Technical Service Bulletin Notification TSB #16-033

TECHNICAL SERVICE BULLETIN

TSB#: 16-033 Job Code: 9803321 Flat Rate: .3 hr

Replace the table top and floor base and table leg for proper fit

FIG 1

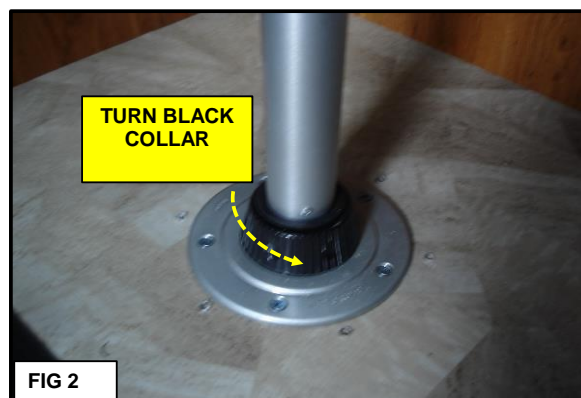
- 1 **Fig 1:** Pull table up and off the table leg
- Fig 2:** Twist, unlock and separate the table leg from the floor base.
